UNITED STATES PATENT AND TRADEMARK OFFICE

APPLICATION NO.	FILING DATE	FIRST NAMED INVENTOR	ATTORNEY DOCKET NO.	CONFIRMATION NO.
09/934,178	08/21/2001	Brian J. Brown	S63.2N-5605-US05	8077
490 7590 07/13/2007 VIDAS, ARRETT & STEINKRAUS, P.A. SUITE 400, 6640 SHADY OAK ROAD EDEN PRAIRIE, MN 55344			EXAMINER PREBILIC, PAUL B	
			ART UNIT 3738	PAPER NUMBER
			MAIL DATE 07/13/2007	DELIVERY MODE PAPER

Office Action Summary

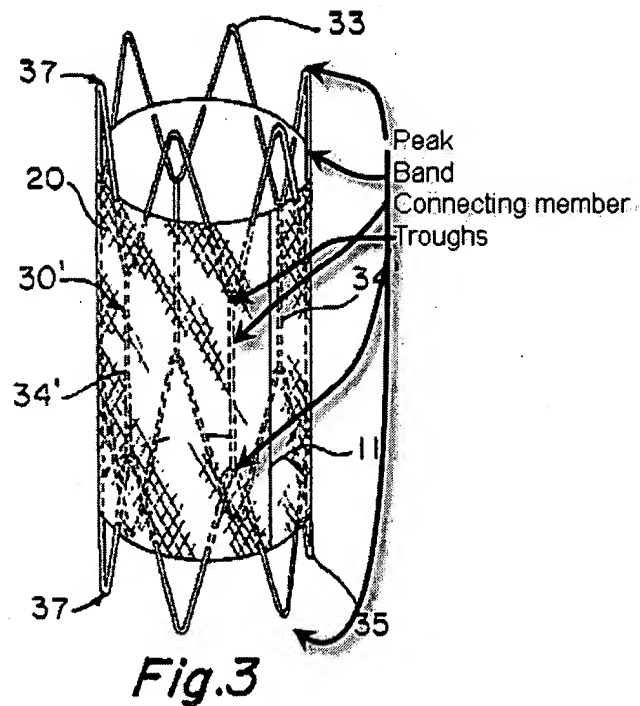
Claims 17 and 19 are rejected under 35 U.S.C. 102(e) as being anticipated by Robinson et al (US 5,935,161). Robinson anticipates the claim language where the peaks as claimed are the pointed ends of the portions of the segments (33 and 35) that extend past the graft in Robinson; see Figure 3.

Applicants traverse the Robinson rejection by stating that it is not clear what elements of Robinson's device correspond to the bands, connecting members, peaks and troughs as claimed. The Examiner though and still thinks that these elements are clear based upon the rejection as stated currently and previously. However, in order to help the Applicants' understanding of the rejection, the following marked up drawing is provided below:
